BLM SCALAR FIX -Based on findbhudda's original design:

Corrected blm-scalar v1.1.brd below & attached: [blm-scalar_v1.1.zip](#)

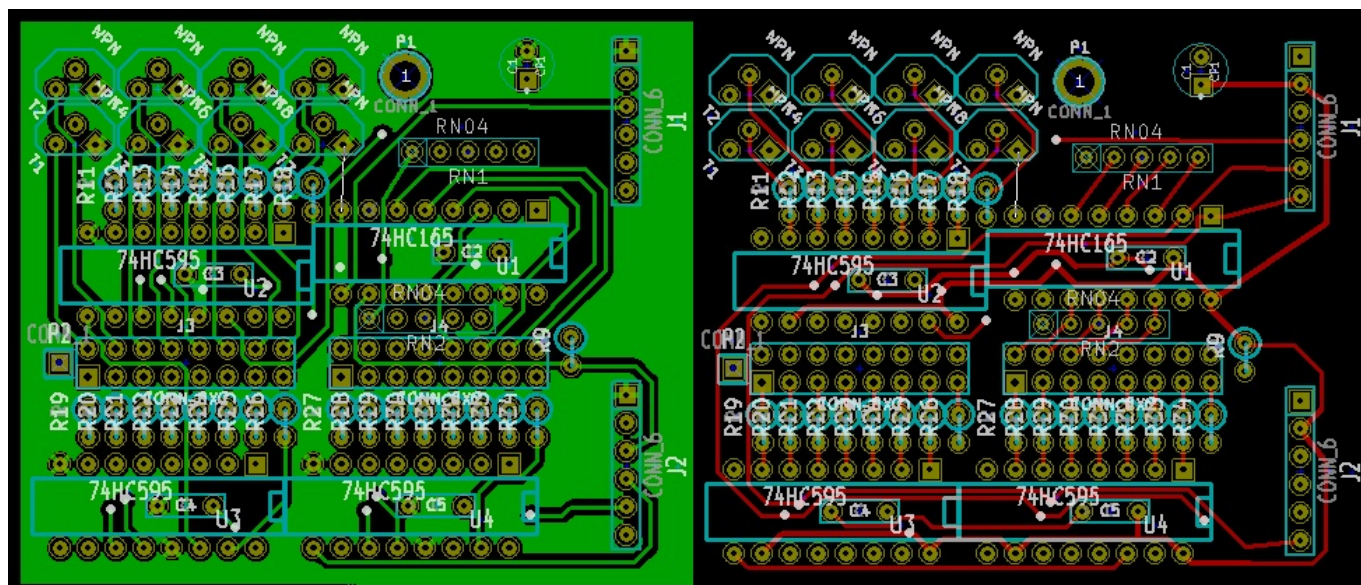
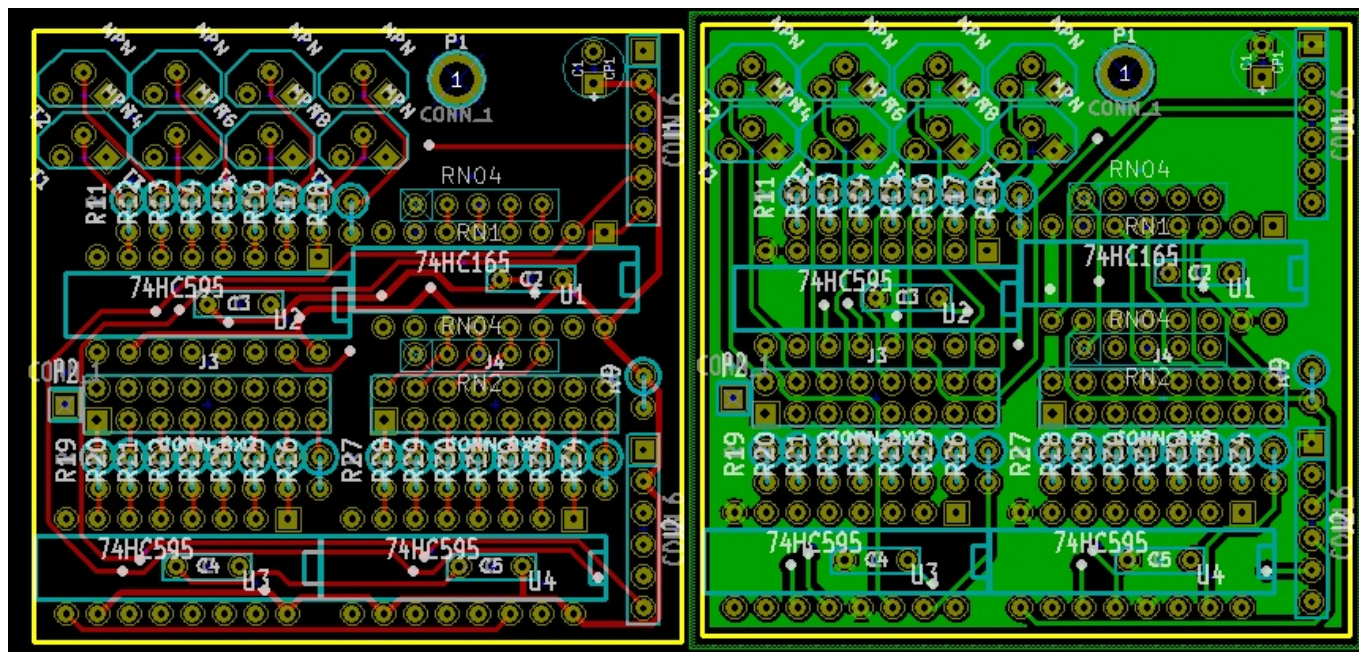
- blm-scalar.* contain an error. Pins I4-I7 are mirrored. This is easily fixed with a connector modification, and the blm-scalar module seems to work as intended.
- blm-scalar v1.1 attempts to fix this error. Moved connectors J1, J2, Resistor Net 1 and R9 to make room for corrections.
